**URGENT: MEDICAL DEVICE CORRECTIVE ACTION**

Regarding: **OLYMPUS ENDOEYE HD II Video Telescope - temperature issue**

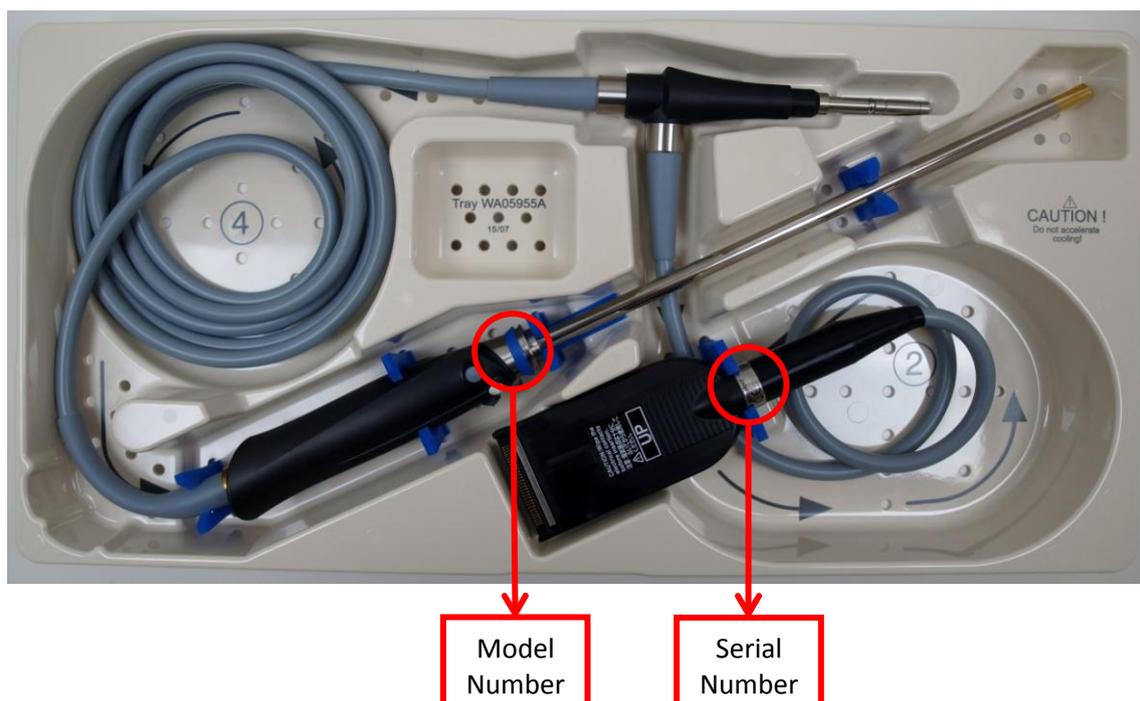
OLYMPUS has initiated this corrective action after discovering that the ENDOEYE distal end can become abnormally hot if the temperature sensor at the device's tip is damaged. Although no customer complaints have been received referring to this issue and thus we are not aware of any patient or user injury, excessive heating of the ENDOEYE distal end could result in patient or user injury. To prevent a potential risk to patient or user health, OLYMPUS is undertaking this action to repair the devices by disabling a specific feature on the video telescopes ("fog-free function") to prevent excessive heating of the ENDOEYE distal end in case of certain faults. An addendum to the instructions for use with your modified devices is enclosed with this letter.

2. Discontinue use of any affected device identified in your inventory.
3. Please note on the enclosed Reply Form that you have received this notification. Olympus requires that you indicate on the attached Reply Form the contact information for your facility so we can schedule a mutually convenient time for an Olympus Field Service Representative to visit your facility to repair the telescope or for return of the telescope to our National Service Center for the repair. Service personnel will repair the devices by disabling a specific feature on the video telescopes ("fog-free function") to prevent excessive heating of the ENDOEYE distal end in case of certain faults.
4. Fax the completed Reply Form to 484-896-7128.
